**Flood Control Project Maintenance
Levee Inspections**

Fall 2016 Levee Maintenance Deficiency Summary Report

Levee District No. 0002 (Glenn County)

Waterway			Bank	Unit Miles
Unit No. 01 Glenn County Sacramento River			Right	4.90
	Spring (March - May)	Summer (June - August)	(September - November) Fall	Winter (December - February)
Unit Maintenance Rating (Fall Only)			U	
Date of Inspection	4/22/2016 - 4/22/2016		9/1/2016 - 9/1/2016	
DWR Inspector	Keith Millard		Tariq Chechi	
Accompanied By	Dennis Clark		Dennis Clark LD 2

Photo 1 of 1 : FA_2016_LD0002_28_30_20160823_00014.jpg

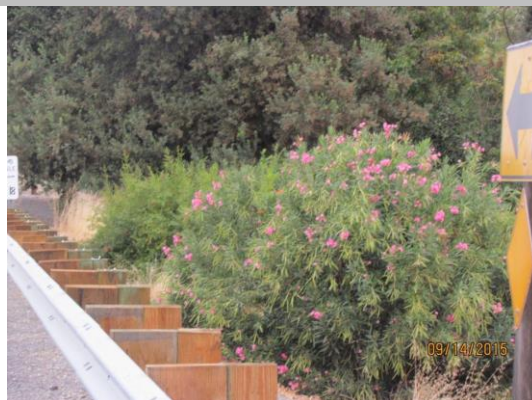
LM Start	1.03	Rating **	M	Issue No.	30
LM End	1.03	Issue Type +	En	Location *	WS
Category	Earthen Levee			GPS Latitude/Longitude	
				Start	End
Item	Vegetation			39.428445 °	39.428445 °
				-122.010972 °	-122.010972 °
DWR ID	DWR_LD0002_01_f_2015_30				
Comment Code					
V6 : Landscaping					
Inspector Comment					
Remove the oleanders from the waterside slope.

View of the oleanders along the waterside slope.
